# 100 Mount Street North Sydney

Project Approval MP08\_0241

Environmental Assessment Report – Modification5

June 2016

FIGURE 2 – NORTH ELEVATION AMENDMENTS

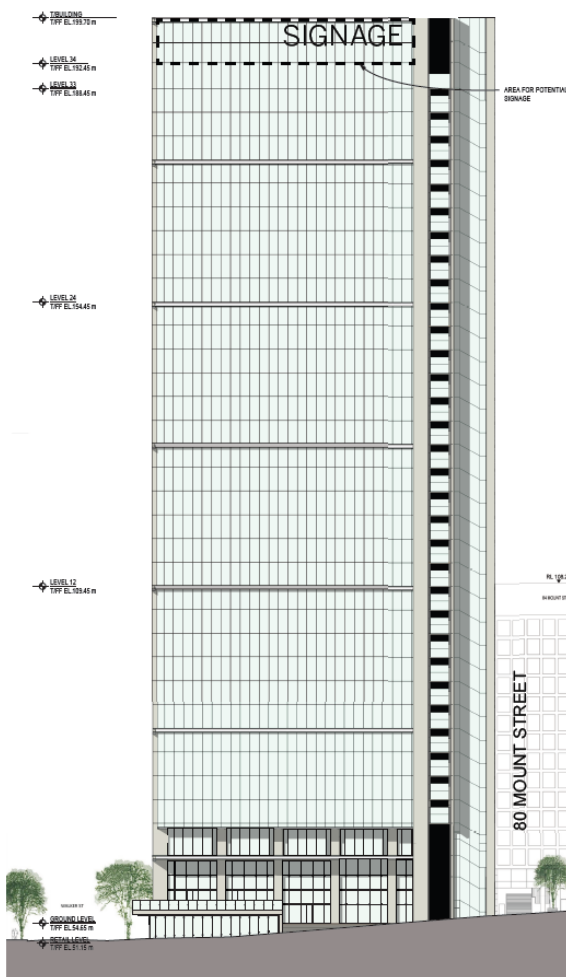
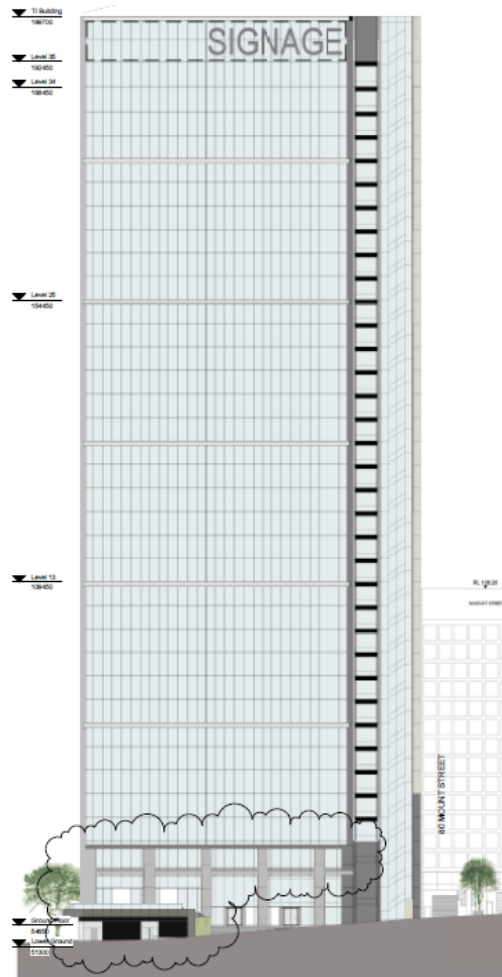
Proposed modifications to the northern façade include:

- Reconfiguration of ground floor level, Level 1 and Level 2 heights as a result of amendments to Level 1 and Level 1 Mezzanine.

These amendments and a comparison between the existing and proposed northern elevations are shown in **Figure 2** below.

FIGURE 3 – EAST ELEVATION AMENDMENTS

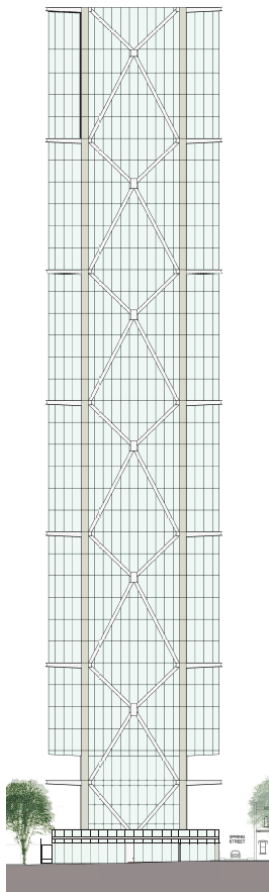
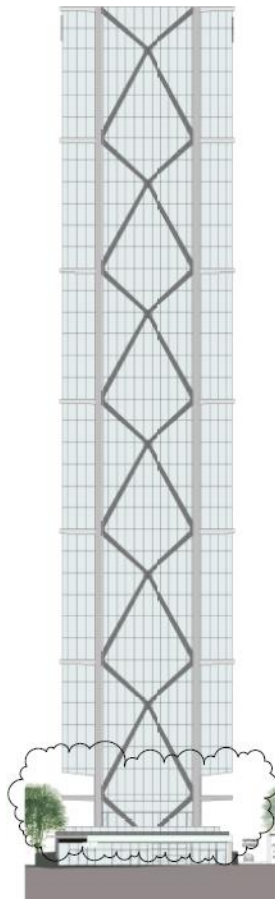
Proposed modifications to the eastern elevation include:

- Extension of ground floor level outdoor seating area and landscape are to Mount Street boundary.
- Reconfiguration of ground floor level, Level 1 and Level 2 heights as a result of amendments to Level 1 and Level 1 Mezzanine.

A comparison of the existing and proposed eastern elevations is provided at **Figure 3** below.

FIGURE 4 – SOUTH ELEVATION AMENDMENTS

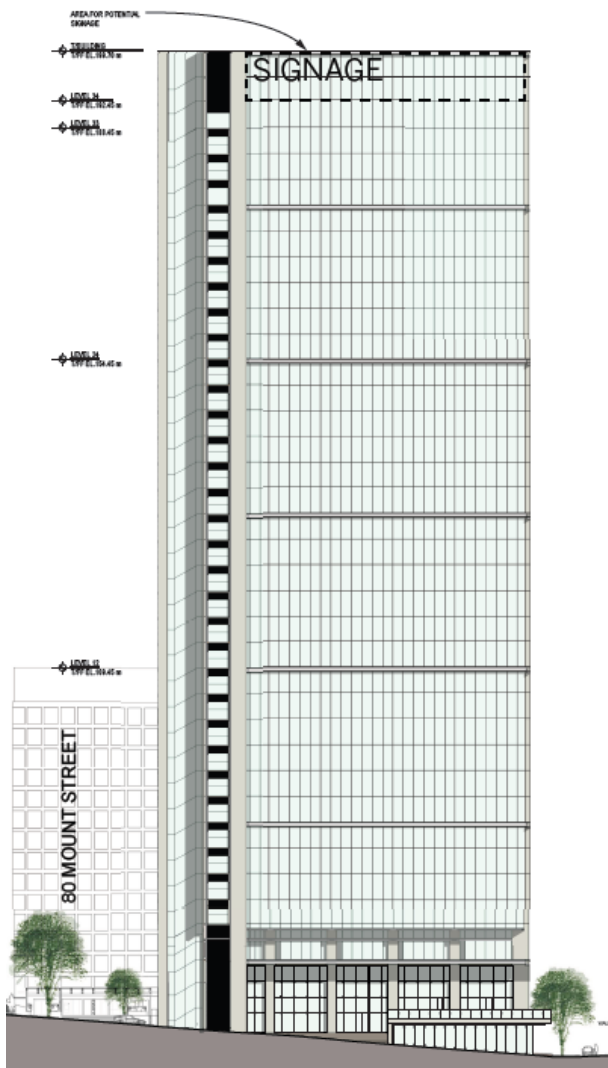
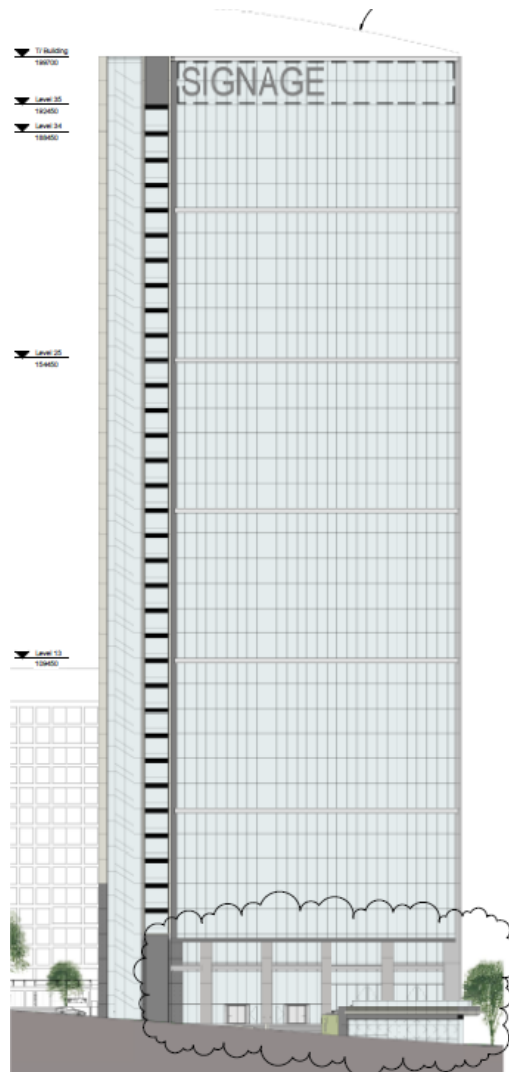
Proposed modification to the southern façade include:

- Replacement of sliding entry doors at the southern, Mount Street lobby entry with revolving doors.
- Reconfiguration of ground floor level, Level 1 and Level 2 heights as a result of amendments to Level 1 and Level 1 Mezzanine.

These amendments and a comparison between the existing and proposed southern elevations are shown in **Figure 4** below.

FIGURE 5 – BASEMENT LEVEL 6 AMENDMENTS

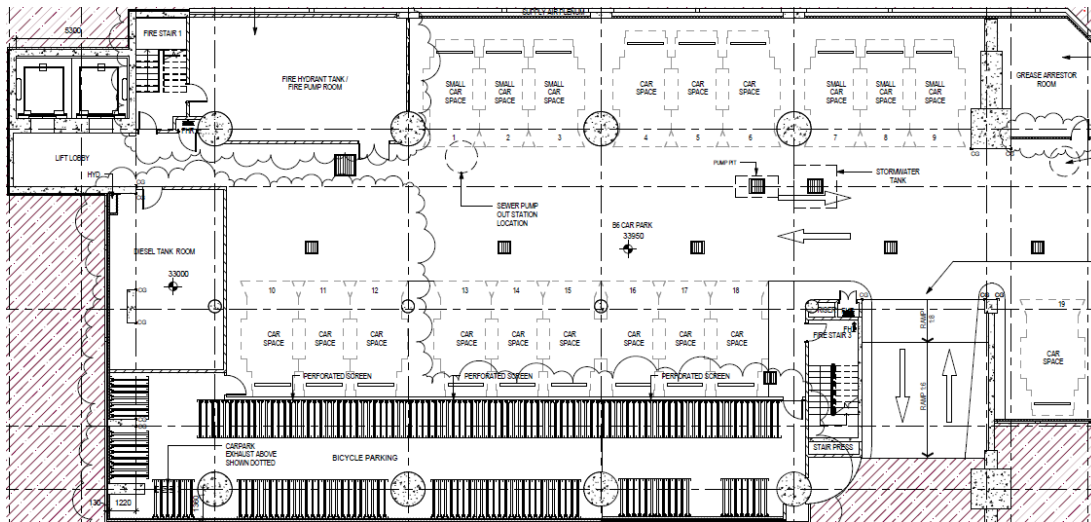
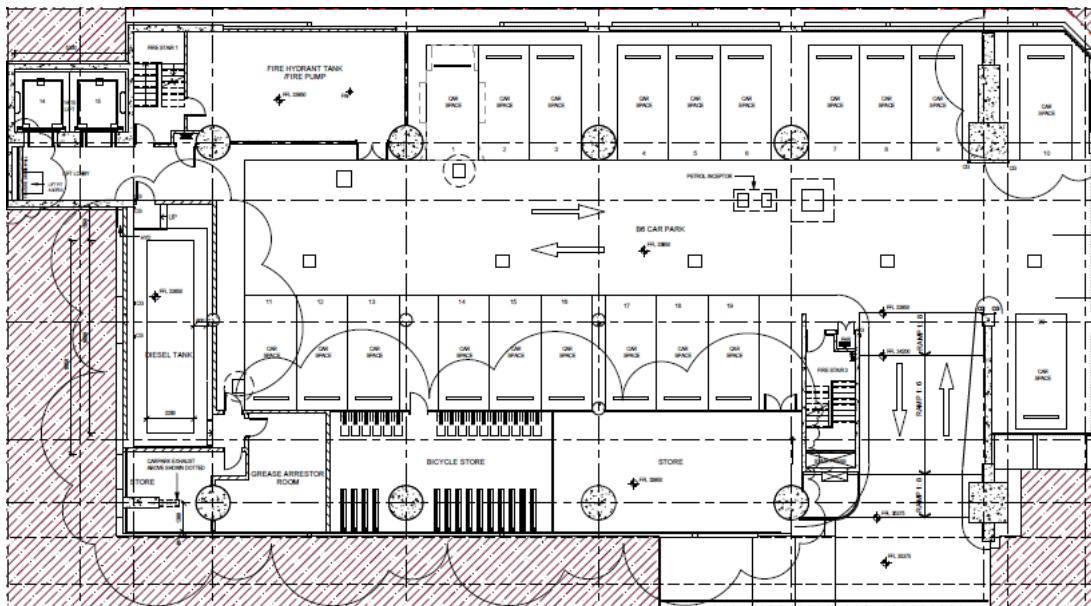
The following modifications are proposed for Basement Level 6:

- Reduction of bicycle parking area to accommodate relocated grease arrestor room and store room.
- Replacement of grease arrestor room with car parking spaces.
- Reconfiguration of diesel tank room.

FIGURE 6 – BASEMENT LEVEL 5 AMENDMENTS

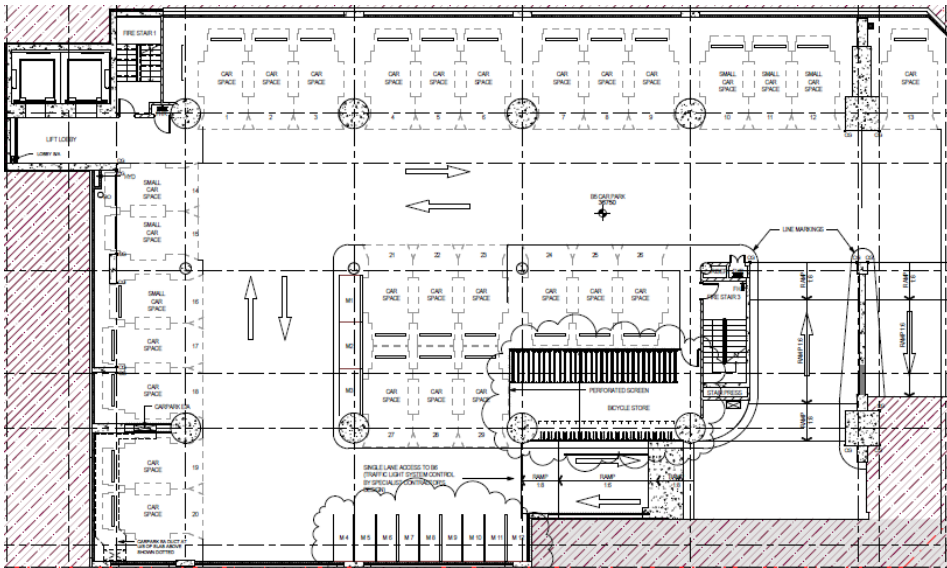
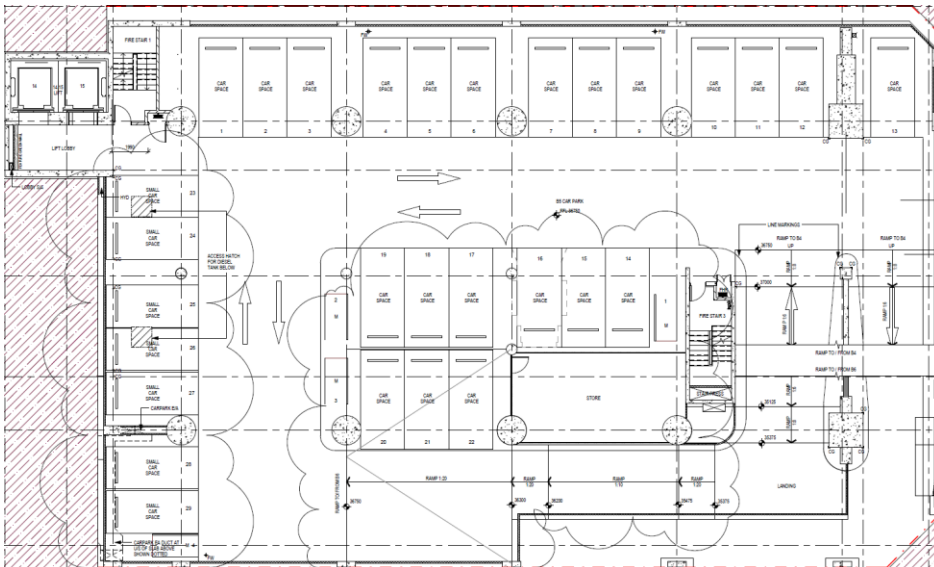
The following modifications are proposed for Basement Level 5:

- Relocation motorcycle parking spaces and deletion of nine spaces along southern wall.

FIGURE 7 – BASEMENT LEVEL 4 AMENDMENTS

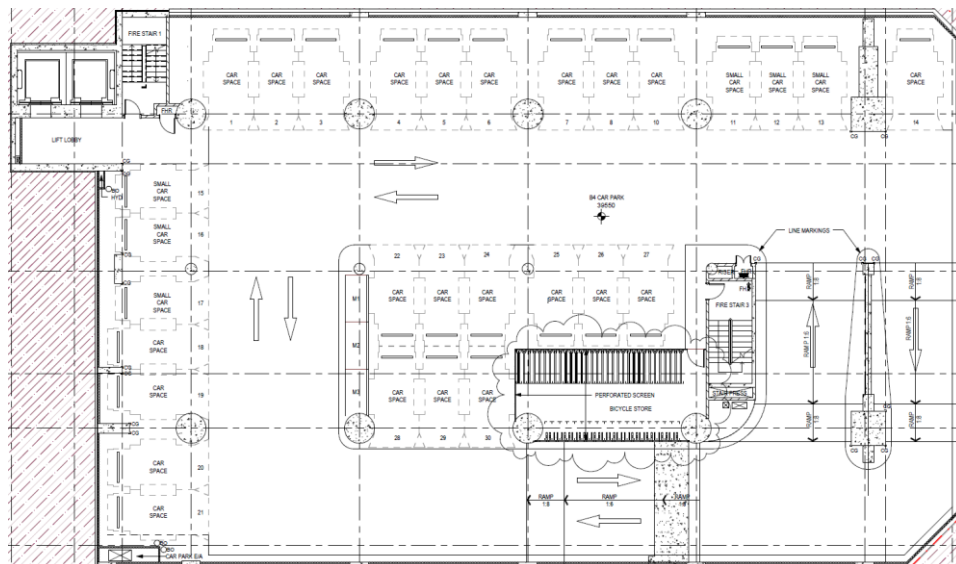
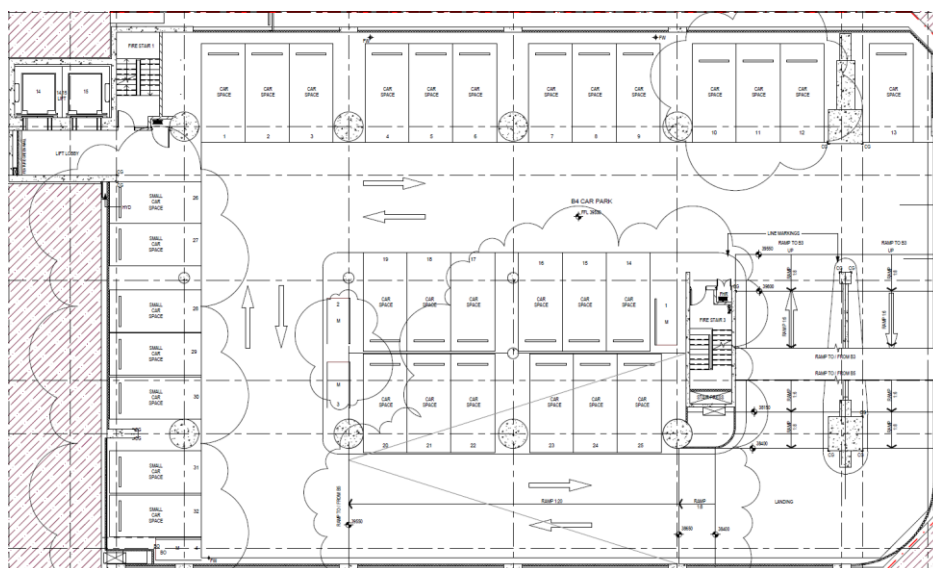
The following modifications are proposed for Basement Level 4:

- Deletion of bicycle store room and creation of three car parking spaces.
- Relocation of motorcycle parking.

FIGURE 8 – BASEMENT LEVEL 3 AMENDMENTS

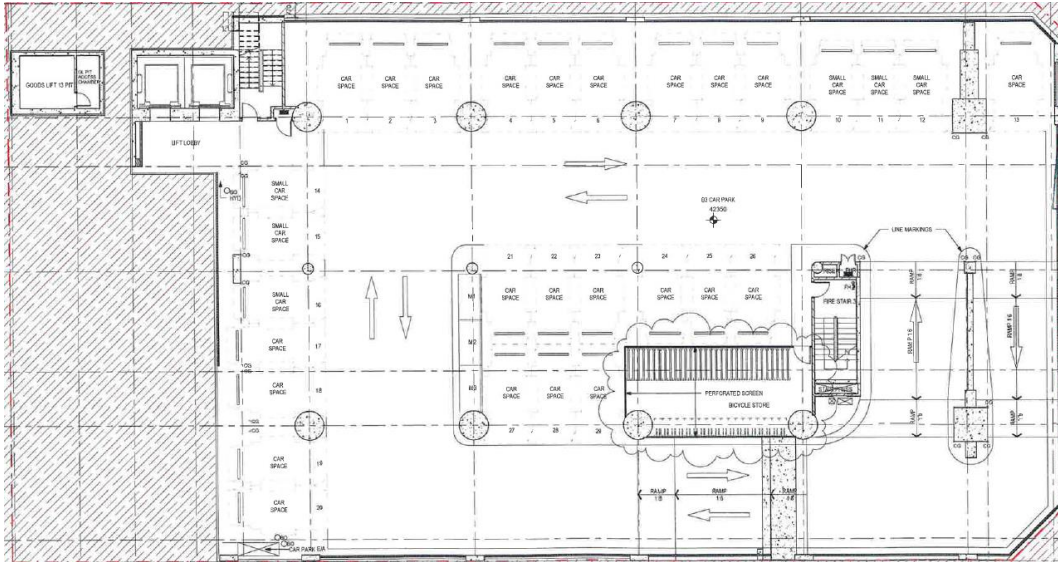
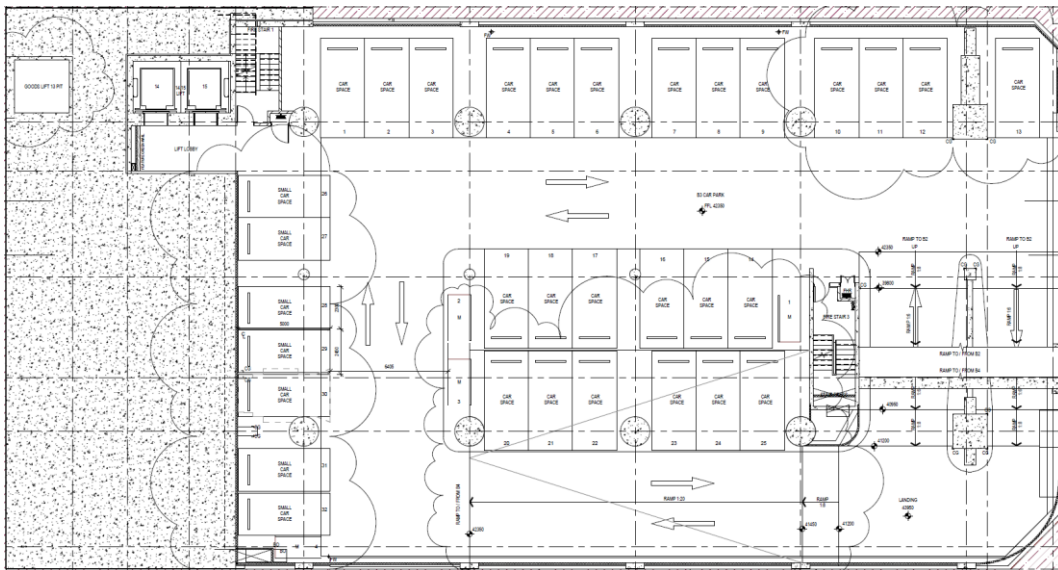
The following modifications are proposed for Basement Level 3:

- Deletion of bicycle store room and creation of three car parking spaces.
- Relocation of motorcycle parking spaces.

FIGURE 9 – BASEMENT LEVEL 2 AMENDMENTS

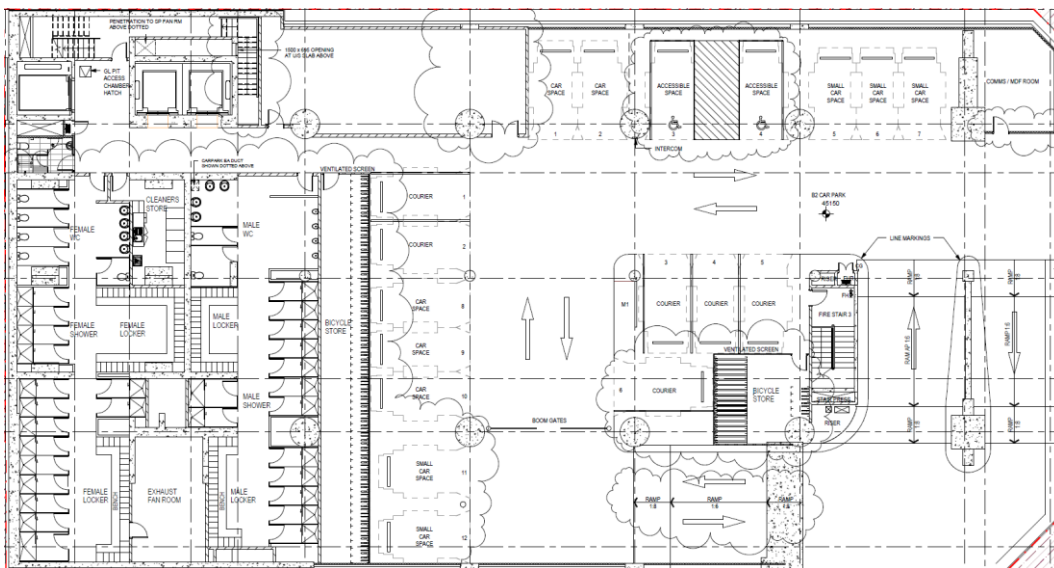
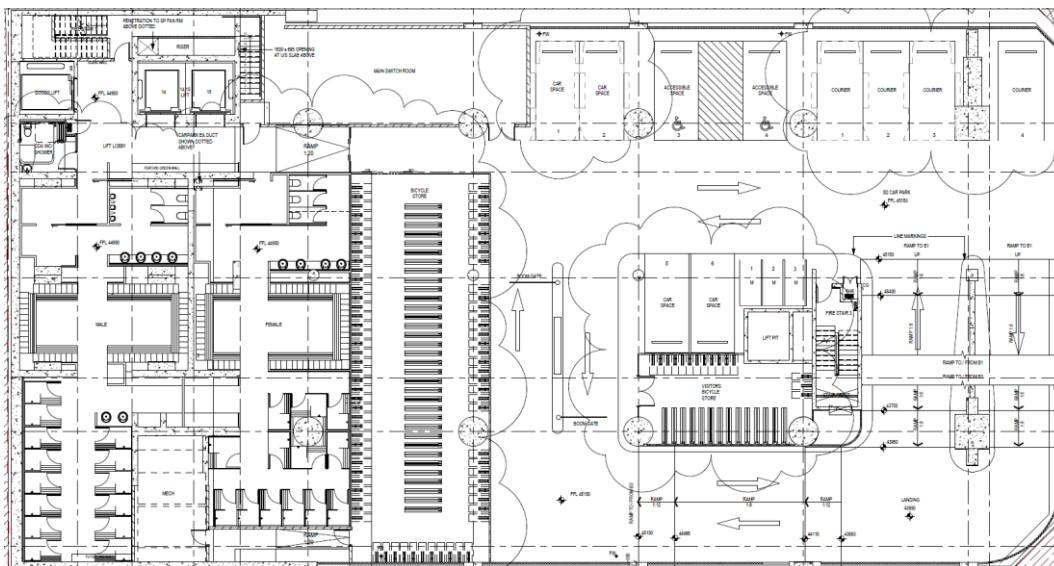
The following modifications are proposed for Basement Level 2:

- Relocation and reduction of courier parking spaces from six to four.
- Extension to bicycle store rooms and dedication of one area for visitor bicycle parking.
- Creation of three motorcycle parking spaces.
- Reconfiguration of end-of-trip facilities.
- Deletion of communications/MDF room.
- Reduction in car parking spaces from 12 to six.
- Relocation of boom gates.

FIGURE 10 – BASEMENT LEVEL 1 AMENDMENTS

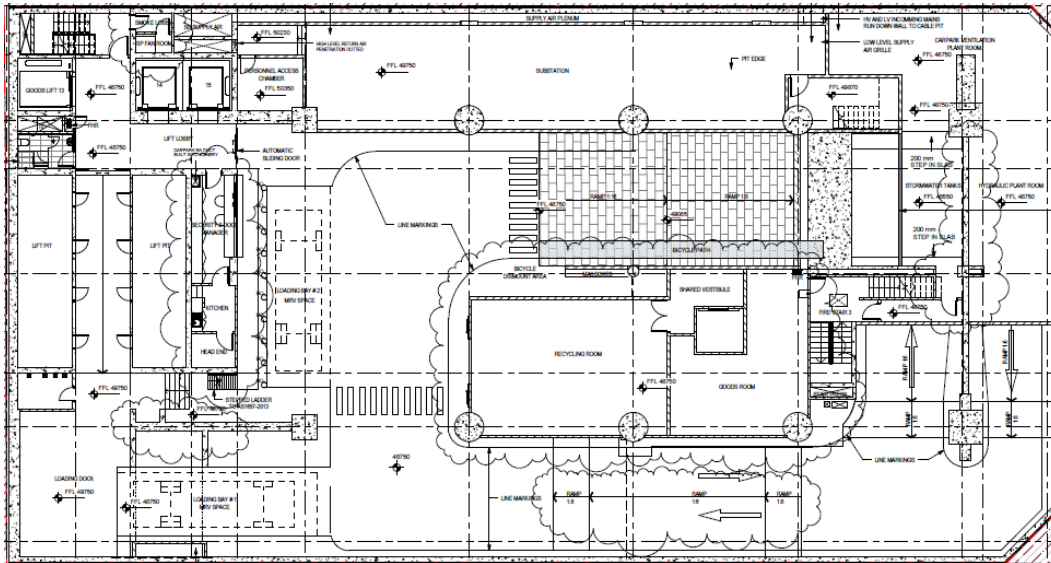
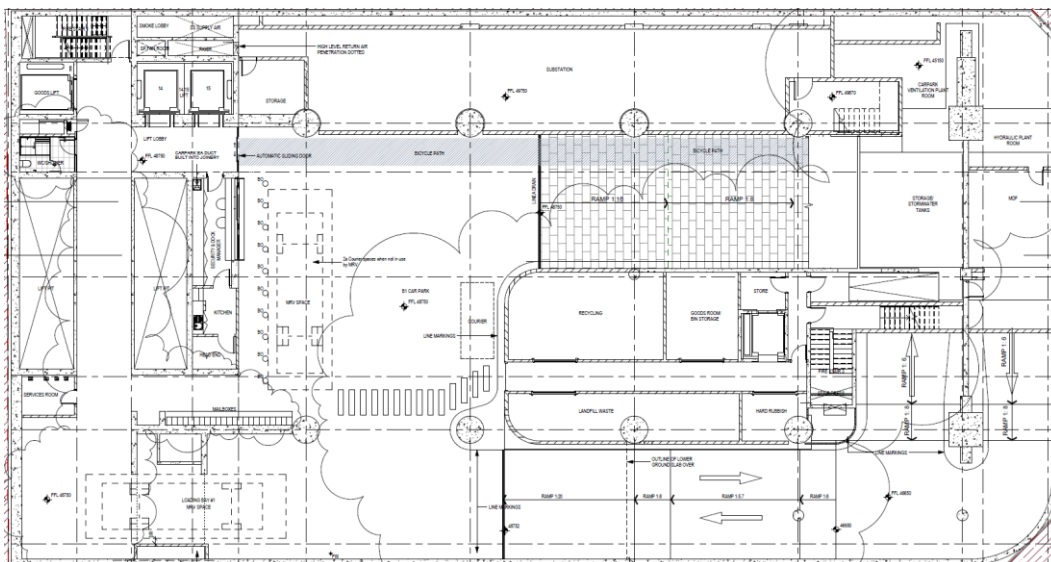
The following modifications are proposed for Basement Level 1:

- Reconfiguration of waste storage rooms, hydraulic plant room, stormwater tanks room and fire stairs.
- Creation of MDF room.
- Relocation of mailboxes.
- Creation of courier parking space and added flexibility of using MRV space as two courier spaces when not in use.
